ADDENDUM NUMBER TWO TO BIDDING DOCUMENTS

**Village of Mount Kisco, Additions/Alterations to
Mutual Fire Station and Independent Fire Co. Fire Station**

Date: February 2, 2022

DRAWING No.
CD 100.02

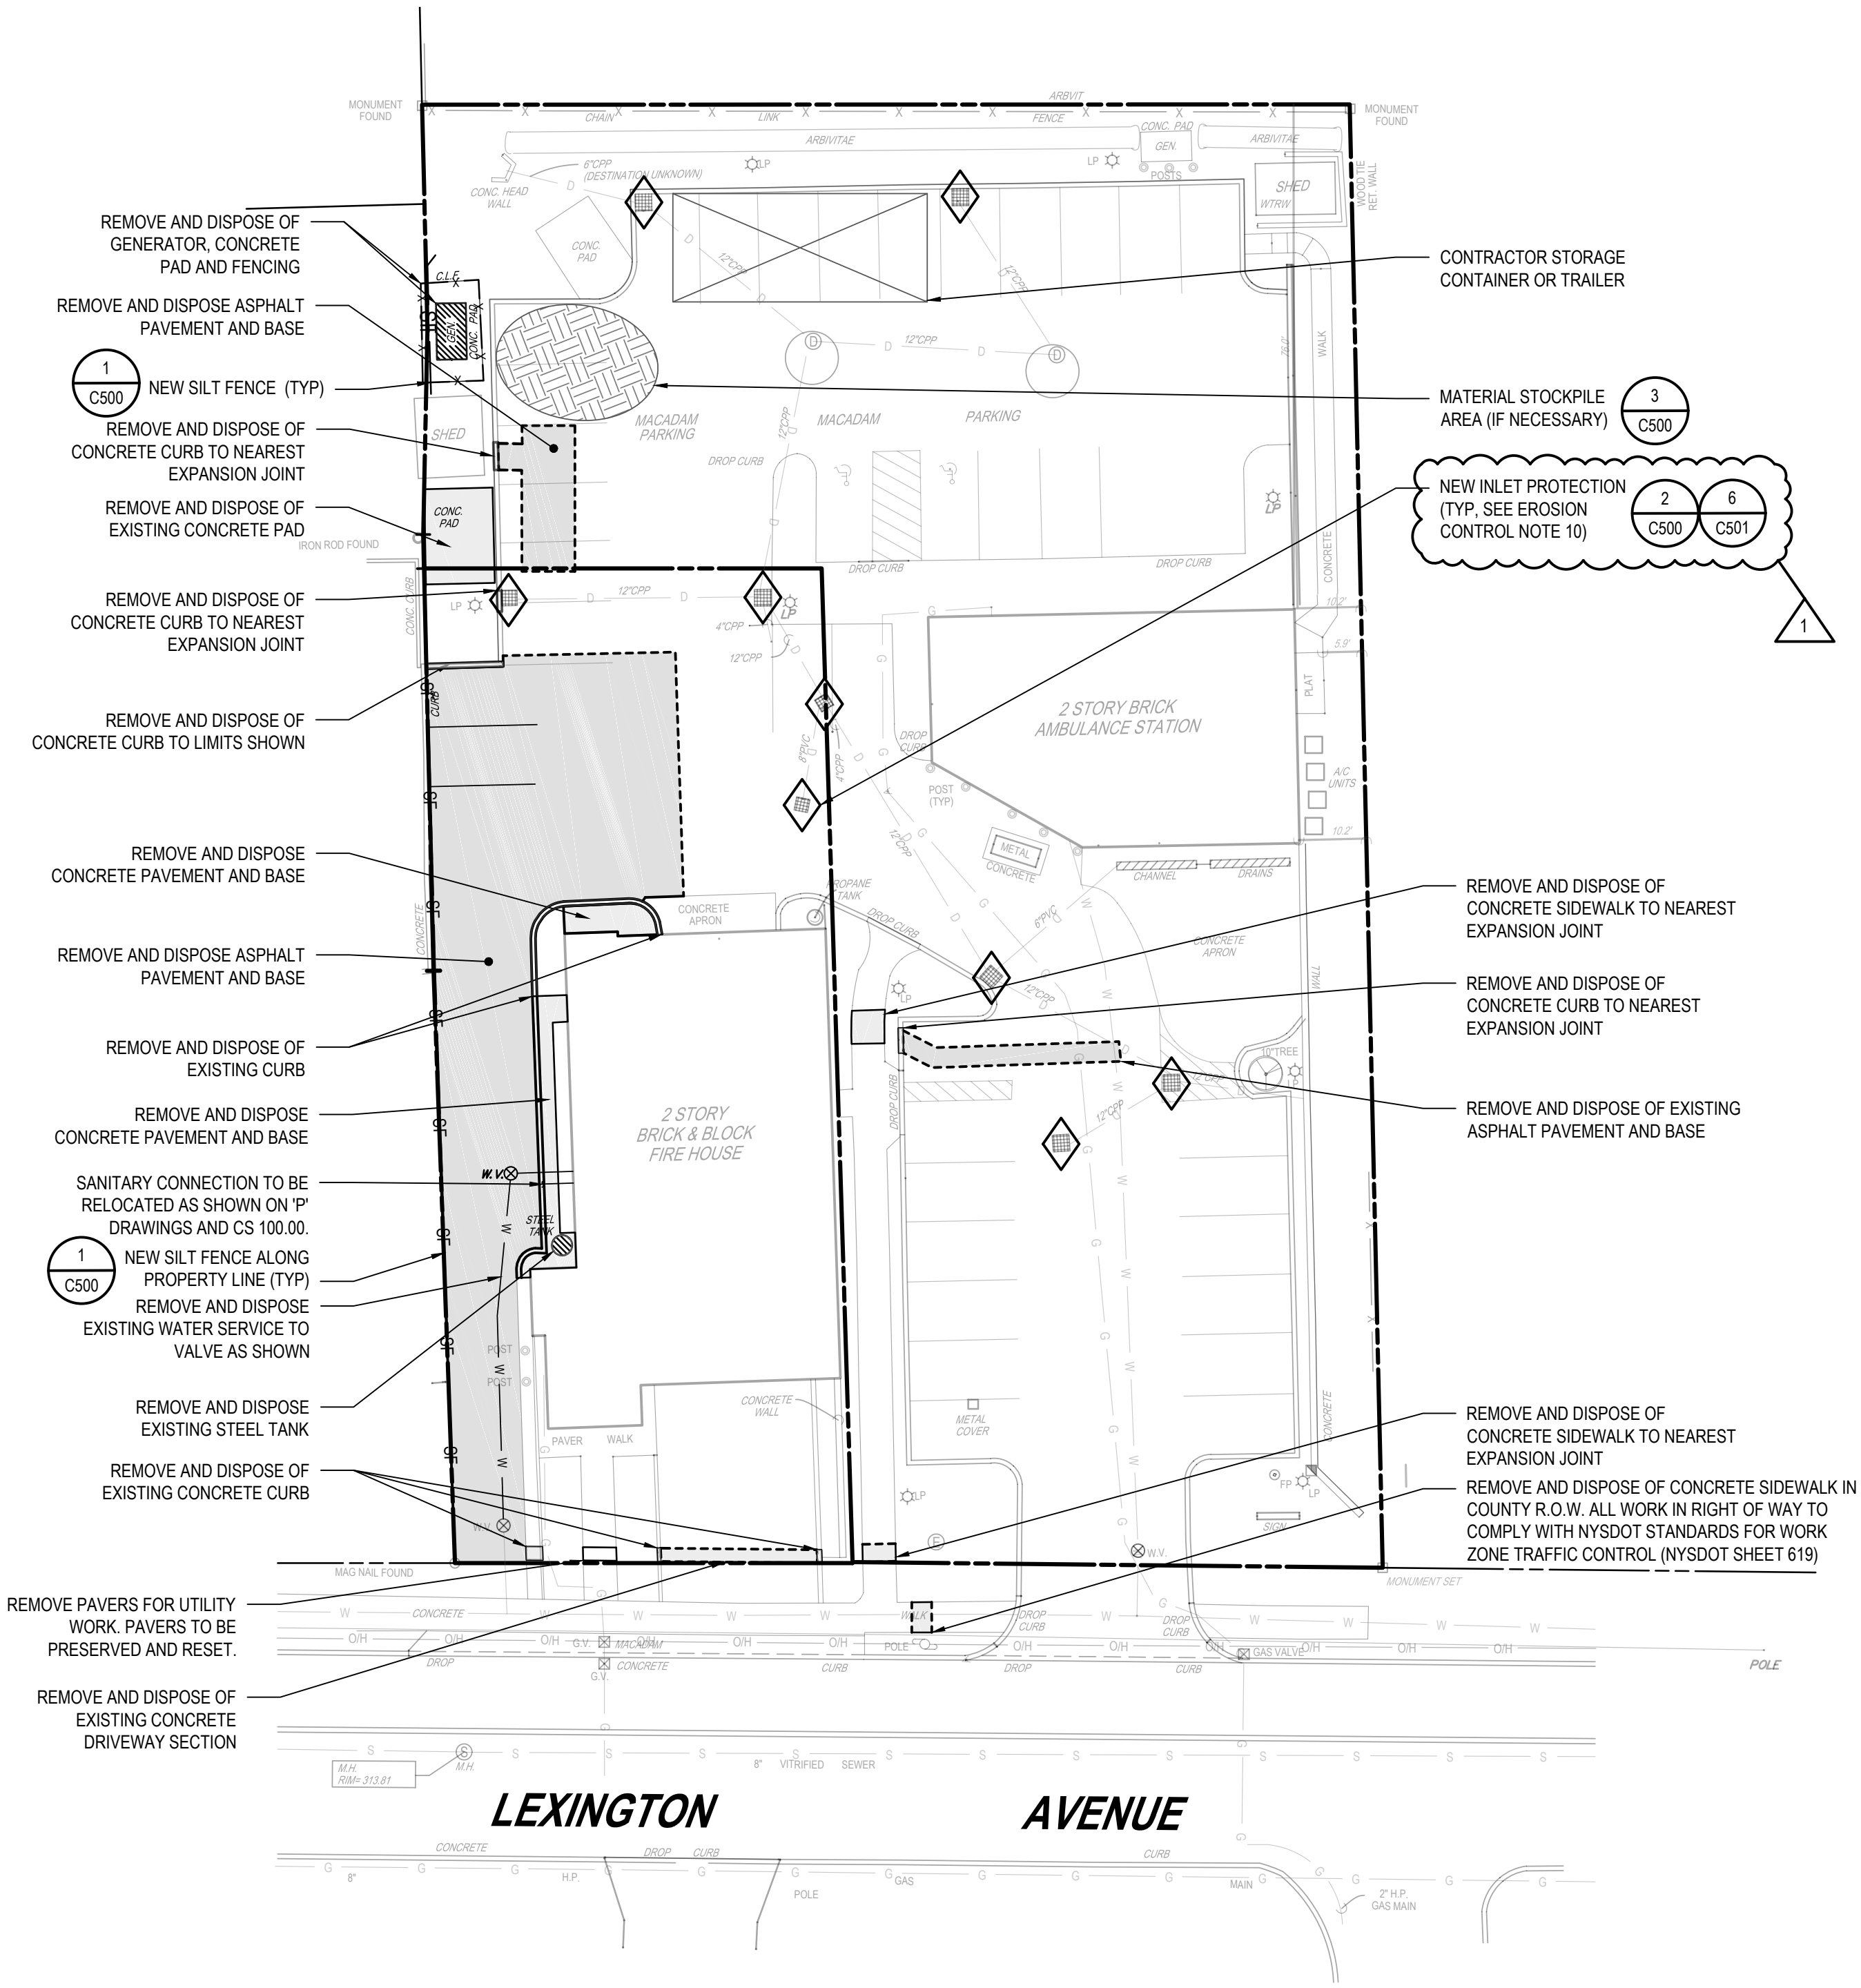
- Q. The Site Dimensional Plan (CS 100.00) for the Independent Fire Co., doesn't have the landscape notes (permanent seeding, soil restoration, temp seeding, etc.) as shown on the Site Dimensional Plan for the Mutual Station. Please confirm that we will not be responsible for these items at the Independent Fire Co. location.
- A. See revised Civil Drawings issued at the end of this Addenda.

Delete the following Civil Drawings and replace with the revised Civil Drawings dated 2/2/2022, located at the end of this Addendum:

Original Drawing No.	Title	Revised Drawing No.
CD 100	Demolition and Erosion & Sediment Control Plan	CD 100.02
C500	Site Details	C500.02
C501	Site Details	C501.02
